Contents

- Item 1. Exhaust Butterfly Cables and Motor Assembly - Daytona 675 and Daytona 675R from VIN 564948
- Item 2. Headstock Washer and Bearing Adjustment - Tiger Sport

Description: **Headstock Washer and Bearing Adjustment**

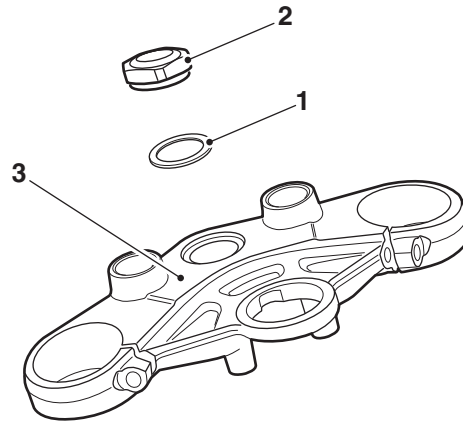
A washer (part number T3551551) has been introduced between the top yoke and the headstock top nut on the above model.

- 1. Washer
- 2. Headstock top nut
- 3. Top yoke

Headstock Bearing Adjustment

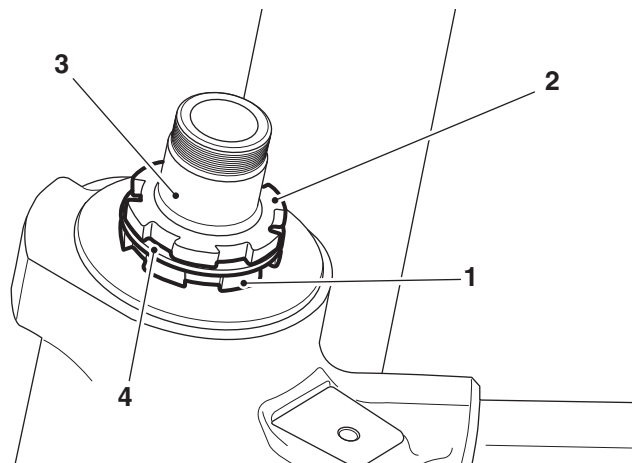
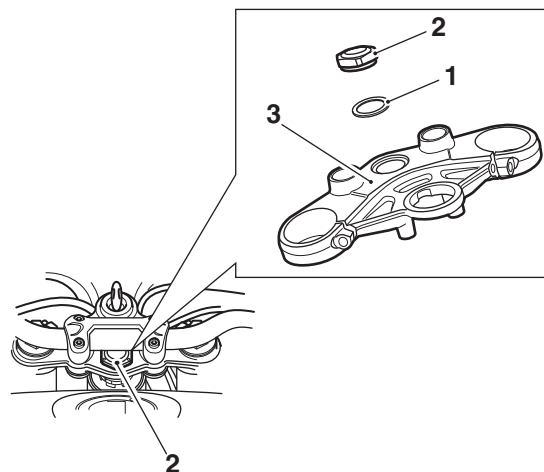
At the same time, the method for adjusting the headstock bearings has also changed.

The adjustment procedure of the headstock bearings in the Service Manual requires updating as described below:

- Remove the lock nut, tab washer and adjuster nut.

- Thoroughly clean the threads on the steering stem.

1. Adjuster nut
2. Lock nut
3. Stem threads
4. Tab washer

- Refit the adjuster nut and tighten to **40 Nm**.
 - Slacken the adjuster nut, then tighten to **8 Nm**.
 - Refit the tab washer and lock nut.
 - Hold the adjuster nut in position while tightening the lock nut to **40 Nm**.
2. Refit the top yoke to the forks.
 3. Fit the washer and the headstock top nut. Tighten the top nut to **90 Nm**.

1. Washer
2. Headstock top nut
3. Top yoke

Description: Ignition Coil Fixings
Models affected: Rocket III Touring and Rocket III Roadster

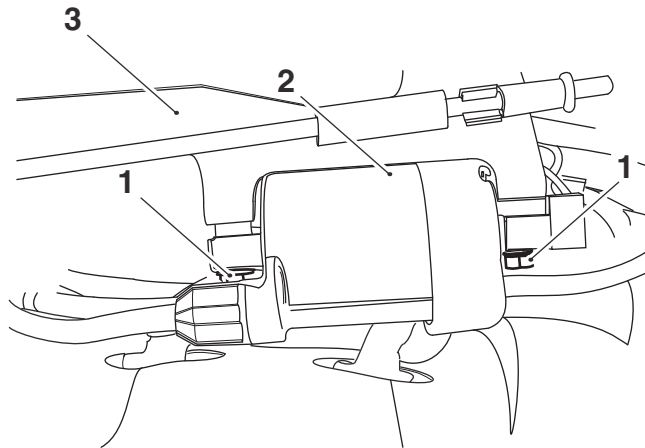
The torque figure for the fixings securing the ignition coils to the mounting bracket has changed to **9 Nm** on the above models.

- 1. Fixings
- 2. Ignition coil (front shown)
- 3. Bracket

Description: Brake Hose Elbow

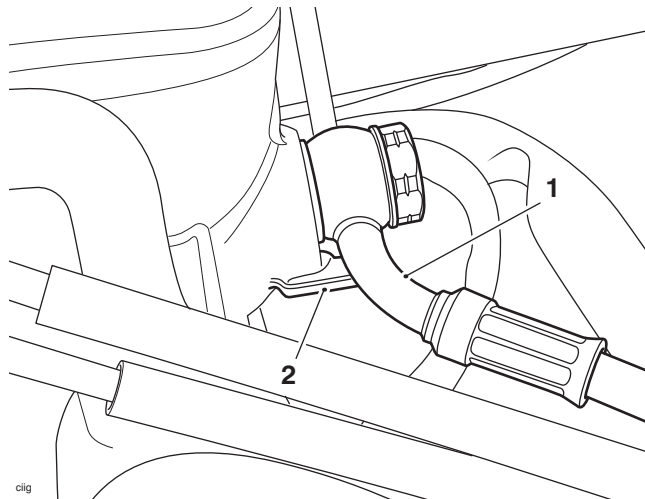
Dealers are reminded that the correct orientation of the front brake hose elbow on the above models is above the stop feature on the brake reservoir and not below as on other models.

If removed for any reason the brake hose elbow must be positioned as shown below.

1. Position a new sealing washer on each side of the brake hose end fitting then secure the hose to the master cylinder with the banjo bolt.
2. Whilst counter-holding the brake hose elbow, tighten the banjo bolt to **25 Nm**.

1. Front brake hose
2. Brake reservoir stop feature

Description: Transition Piece

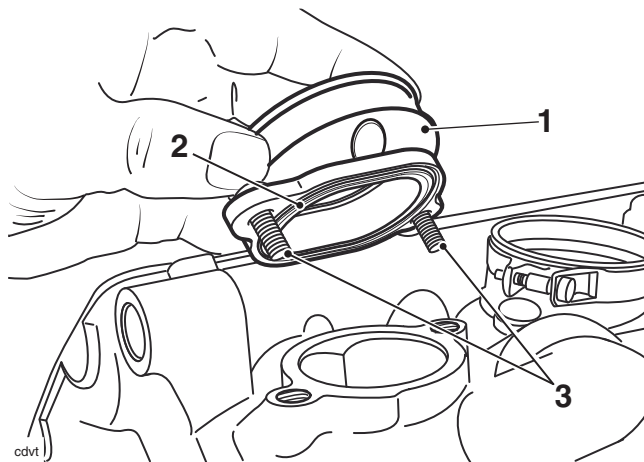
Revised transition pieces have been introduced to the above models and are NOT retrofittable. The removal and installation of the transition pieces is as described in the Service Manual noting the following:

- The new transition pieces have a built-in rubber bead so the original O-rings are no longer required.

New encapsulated fixings have also been introduced. These must be replaced and tightened to **8 Nm** if they are loosened or removed.

If a transition piece has been removed for whatever reason, check the rubber bead for damage before refitting. If damaged fit a new transition piece.

1. Transition piece

2. Rubber seal

3. Fixings

Description: Sprocket Cover Fixings M6 x 16 mm

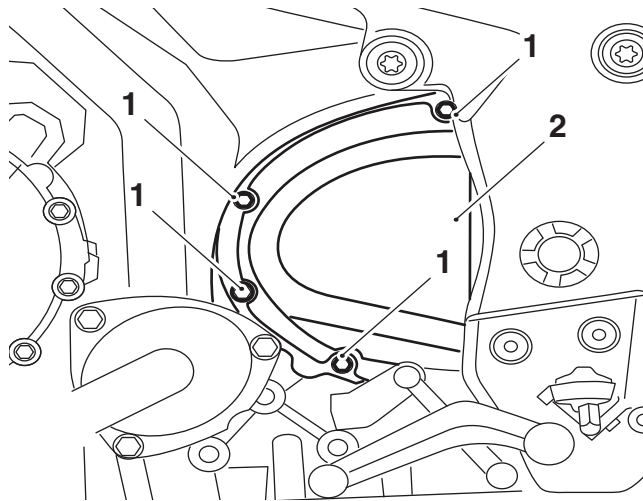
The sprocket cover fixing torque has been reduced on the above models. In addition the length of the fixing has been increased to 16 mm.

The revised torque is **7 Nm**.

- **The M6 x 16 mm fixings need not be re-tightened unless they have been loosened or removed.**
- **The M6 x 12 mm fixings must be replaced with M6 x 16 mm fixings if they have been removed for any reason.**

1. Sprocket cover fixing

2. Sprocket cover

Description: **Alternator**

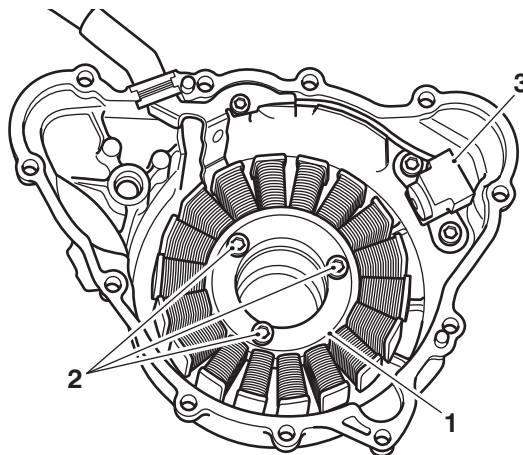
A new alternator assembly has been introduced to the above models from VIN 614941 and is not retrofittable. When ordering replacement parts, always refer to the EPC.

The main differences between the original condition and new condition alternator are as follows:

- The stator
- The rotor
- The rotor retaining bolt
- The alternator cover
- The crankshaft position sensor
- The method of oil cooling the alternator.

From VIN 614941 to aid the cooling of the alternator, oil is taken from the crankshaft oil feed and directed to the alternator via a drilling in the alternator bolt.

1. Stator
2. Stator fixings
3. Crankshaft position sensor

Description: Selector Drum and Neutral Light Switch Parts Kits

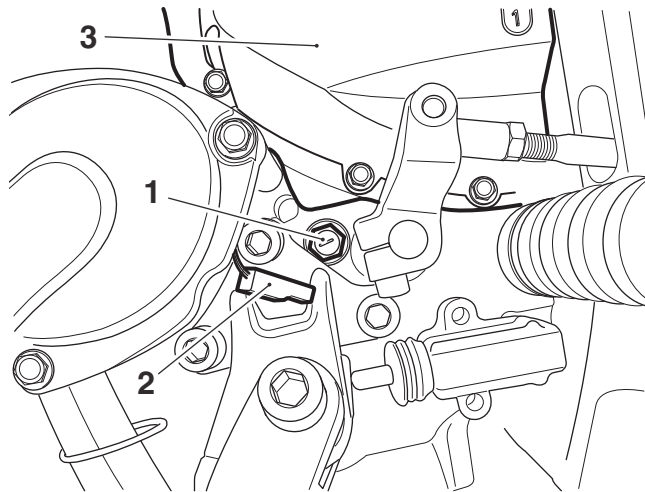
If for any reason the selector drum requires replacing the neutral light switch will require adjustment, therefore a parts kit including a 1.5 mm (silver) washer and a 0.9 mm (black) washer are included.

1. Neutral light switch - Speed Triple shown
2. Neutral light switch connection
3. Sprocket cover

4. Fit the neutral light switch and the 1.5 mm (silver) washer. Tighten to **10 Nm**.
5. Reconnect the neutral light switch to the main harness.
6. Reconnect the battery as described in the relevant Service Manual for each model. Do not refit the seat/battery cover at this stage.
7. Turn the ignition key to the ON position and ensure that the engine stop switch is in the run position.

Description: **Alternator**

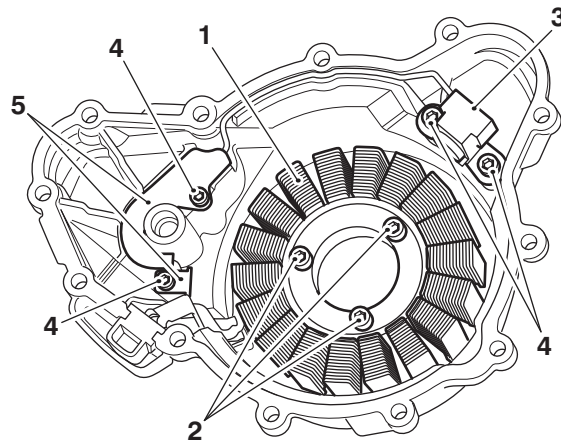
A new alternator assembly has been introduced to the above models from engine number 612714 and is not retrofittable. When ordering replacement parts, always refer to the EPC.

From engine number 612714 to aid the cooling of the alternator, oil is taken from the crankshaft oil feed and directed to the alternator via a drilling in the alternator bolt.

- **Note the routing of the harnesses for installation.**
2. Remove and discard the fixings securing the stator to the alternator cover.
 3. Remove and discard the fixings securing the two cable brackets to the alternator cover.
 4. Remove and discard the fixings securing the crankshaft position sensor to the alternator cover.

1. **Stator**
2. **Fixings**
3. **Crankshaft position sensor**
4. **Fixings**
5. **Cable brackets**

1. Fit the rotor, as described in the Service Manual.
2. Fit the stator to the alternator cover and tighten its new fixings to **12 Nm**.
3. Fit the crankshaft position sensor to the alternator cover and tighten its new fixings to **6 Nm**.
4. Route the harnesses as noted for removal, fit the cable brackets and tighten their new fixings to **6 Nm**.
5. Fit the alternator cover, as described in the Service Manual.

Description: Instrument Fixings

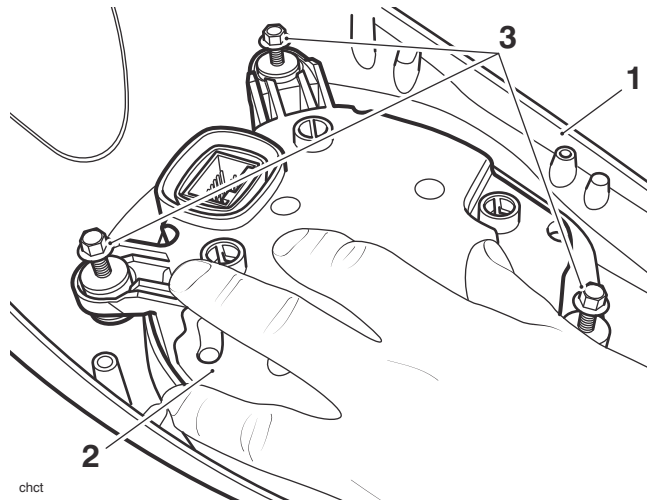
The torque figure for the instrument fixings has changed to **1.5 Nm** on the above models.

1. Instrument nacelle
2. Instrument assembly
3. Fixings
